Planning Review Memorandum

Re: Ryan Osburn Offices – Tax Lot 81033AA00700

RE: Ryan Osburn Offices – Tax Lot 81033AA00700

This is a review of the preliminary plans for the **Ryan Osburn Offices – Tax Lot 81033AA00700**.

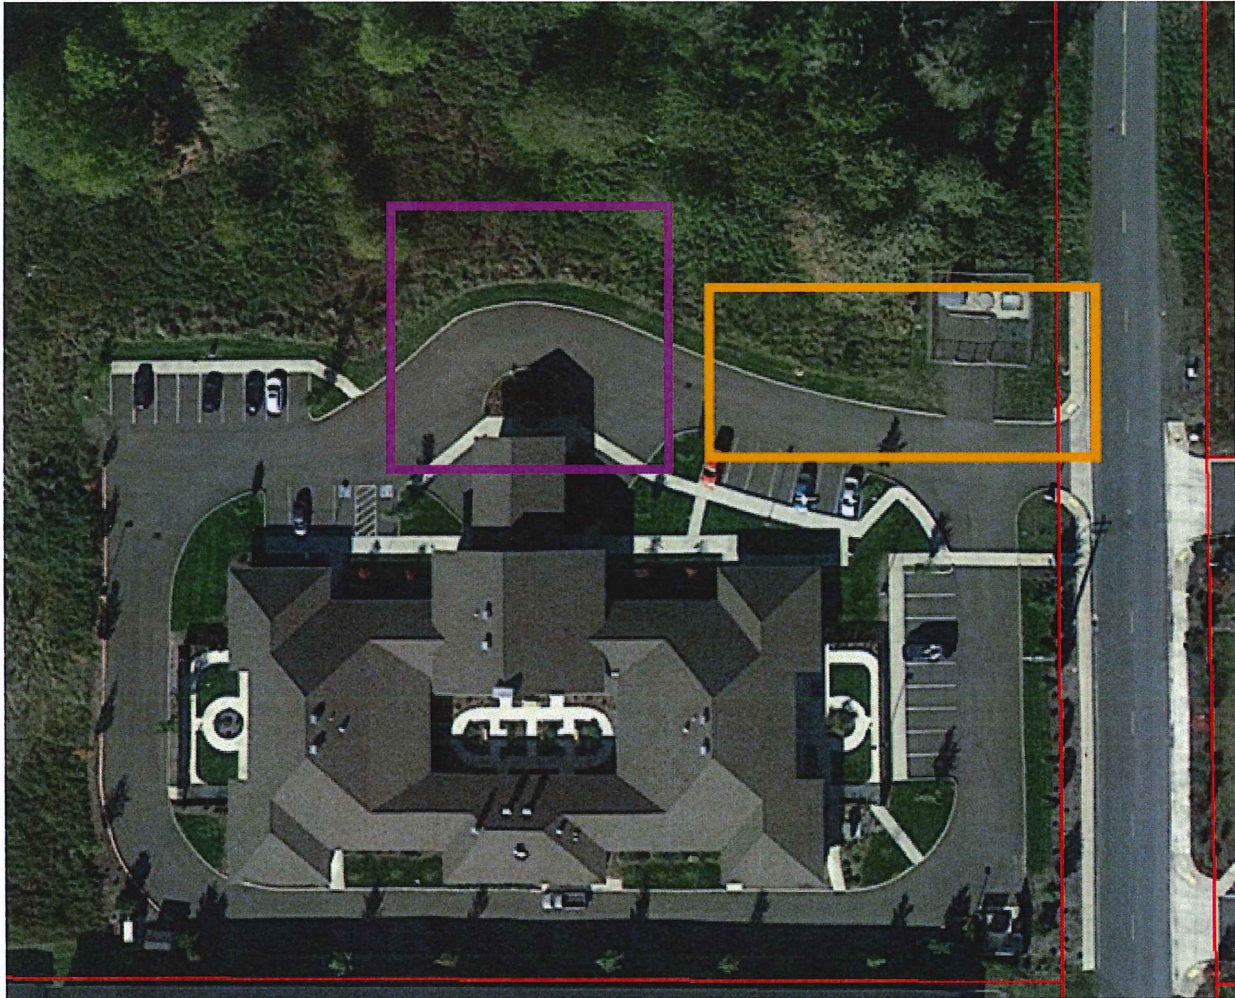
15. It is unclear from the provided plans how the proposed road will interact with the existing Memory Care facilities. This will be looked at in more detail once planning documents have been submitted to the City.

See Pink Square in Image Below. The applicant will need to provide additional traffic design features at this location that will prevent driver confusion and accidents.

OSBURN PLUMBING
 SITE DEVELOPMENT
 PRELIMINARY SITE PLAN
 100120000
 100120000
 100120000

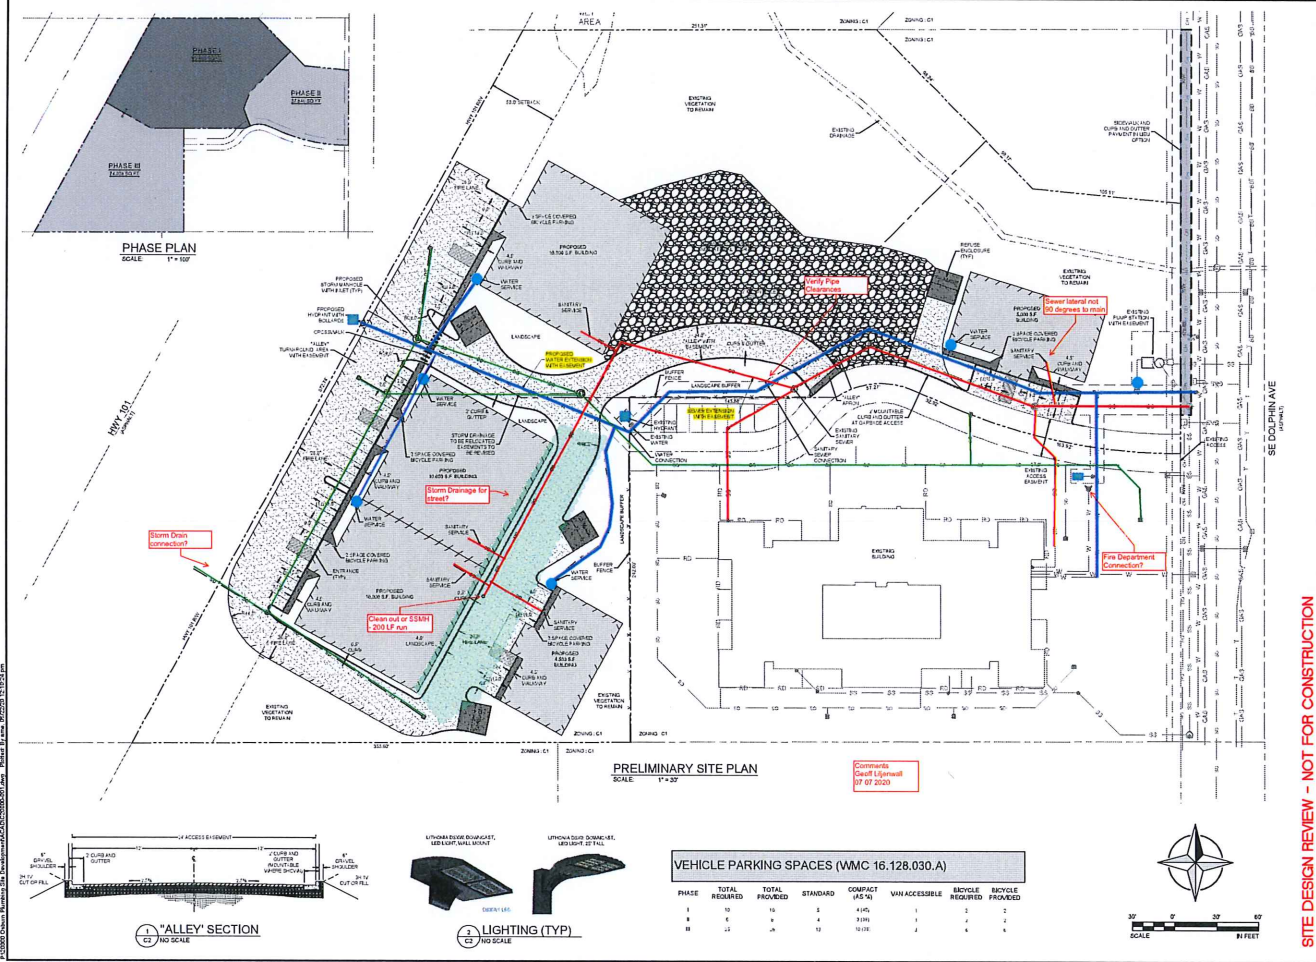
Sheet C2 – Preliminary Site Plan:

This is based on the preliminary design. There might be utility conflicts that are not shown.

NW Natural Gas and Pacific Power and Light (PP&L) - should provide a preliminary design to coordinate the easements and the underground utilizes.

Building 10,000 SF (North):

Sewer: New (or existing) Sewer Manhole (SSMH) at the South East corner of the building:

- Will that interfere with the building foundation?
- Future underground repair – limited room for any excavation
- Note: As per preliminary plans – unknown if this is an existing SSMH.
- Section 4.3.6 Manhole odor control – close to proposed building

Building 20,000 SF (South):

Sewer: Note that the sewer main serving this building is 200 LF (+) – will have a potentially low flows from only 3 connections. As per City requirements 4.2.2 Sanitary Sewer Main Pipe Size – “For dead-end lines up to a maximum length of 250 feet... will be allowed”.

Recommendation that a full size sewer manhole be installed for ease of cleaning and inspection. A 6” cleanout limits the options for servicing the line.

Storm:

- Southwest corner – Last catch basin – is there an outfall or connection to the west of this basin?
- Road (east of building) – running north/south: What is the proposed storm drainage for that road
